Westwind – Stormwater Management (Contract 9130, MUNIS 13921)

EXHIBIT OF IMPROVEMENTS:
WESTWIND - PHASE 2
BOARD OF PUBLIC WORKS 05/20/2026

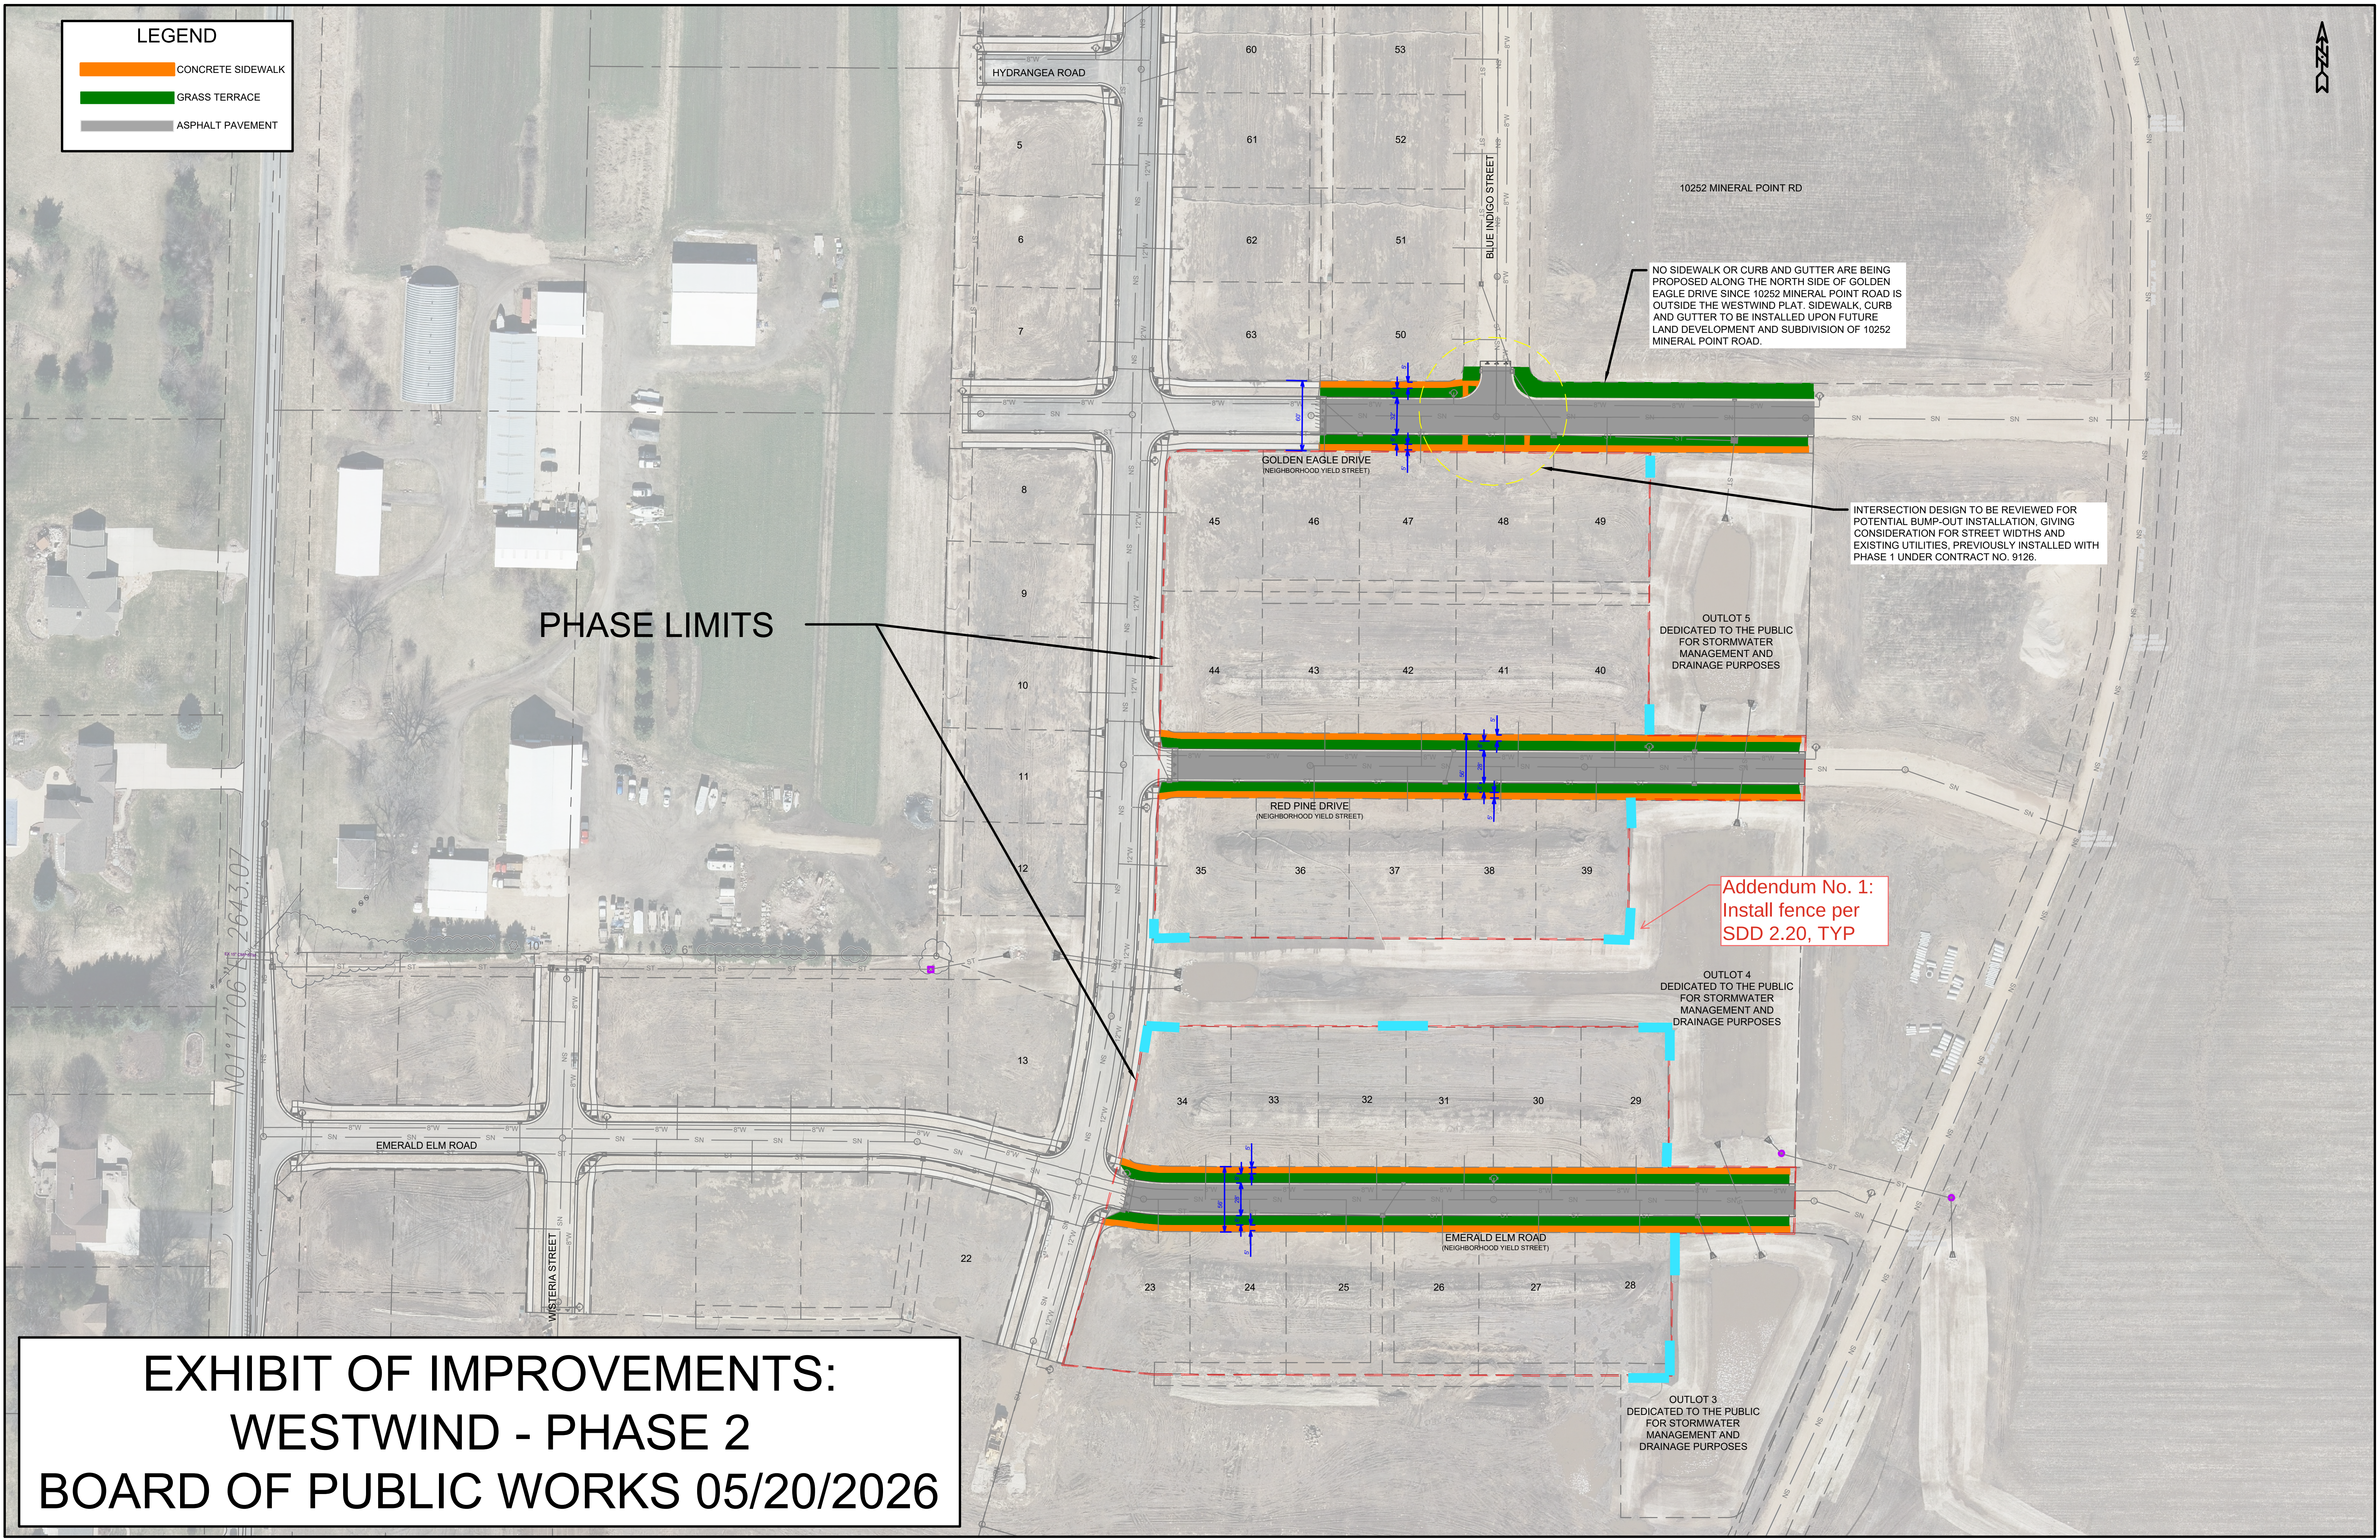
ADDENDUM No. 1: Replace boundary markers for split rail fence per SDD 2.20

Addendum No. 1:
Install fence per
SDD 2.20, TYP
